INDESIT company

Model type:
WITL106EU

Commercial code:
F034268

1140960 Exploded views

N1040345fig1

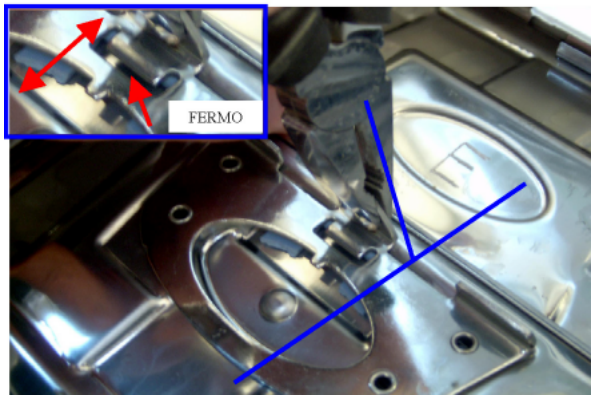
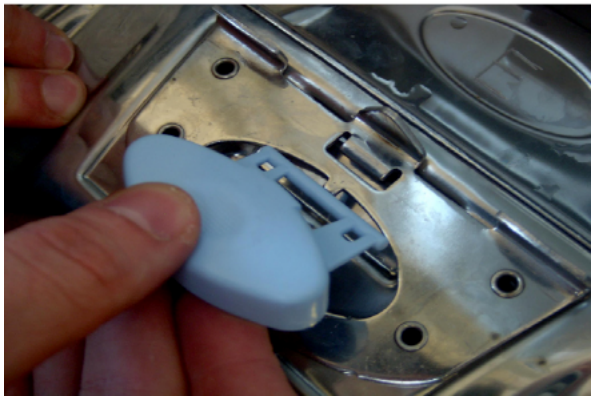
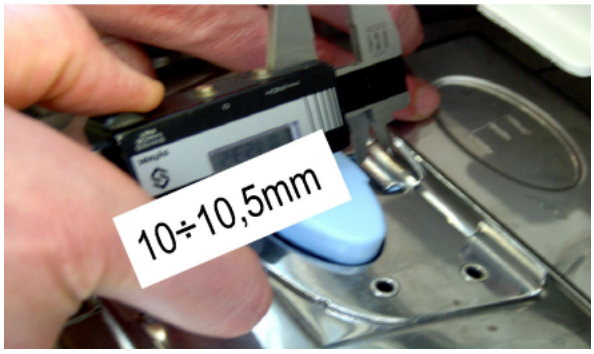
n1040345: Replacement of drum lock button TL EVOII.

Tools and material needed: pliers, screwdriver, gauge, spring P/N Sat 114989, button P/N Sat 114990.

1) turn the central tip of the catch in the direction shown (FIG.1);

2) bring the tip to a vertical position and ensure that the broken button is disengaged from the catch restraint and can be removed (FIG.2);

3) remove the remaining part of the button with the aid of a screwdriver, taking care not to scratch the doors (FIG.3);

4) pre-assemble spring to button (FIG.4);

5) insert button between catch and door (FIG.5);

6) bring the button into position and arrange the spring in its location in the door (FIG.6);

7) turn the central tip of the catch in the direction shown to return it to its starting position (FIG.7);

8) check the distance between button and catch (FIG.8);

9) check correct operation of the button when opening and closing the doors (slight inclination errors of the catch can result in faulty closing of the doors) (FIG.9).

n1040382: Drain pump with bayonet-style filter - top Loading Brembate

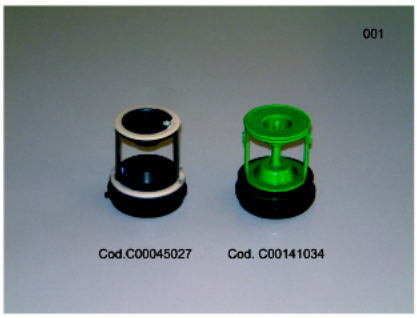
From serial no. 51021.0001 a new drain pump with bayonet-style filter has been installed on all top loading washing machines manufactured in Brembate.

New parts:
C00141862 - Drain pump
C00141034 - Pump filter kit

Premodification parts:
C00111409 - Drain pump
C00045027 - Pump filter kit

The new parts can be used instead of premodification ones.

N1040404FIG1

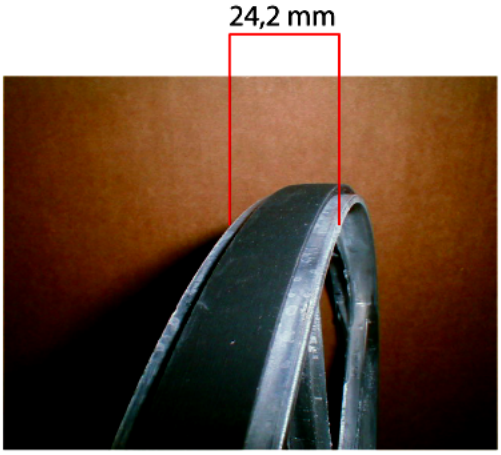
n1040404: New pulley installed on top loading washing machines up to 1000RPM (NO tub lock)

From serial no. 51202.0001 the pulley track has been widened from 21.2mm to 24.2mm (see picture N1040404FIG1).

new pulley
C00142832 - D280 24.2 mm track

Premodification pulley
C00083912 - D280 21.2 mm track

The new pulley can also be used on premodification versions of the models referred to in this release.
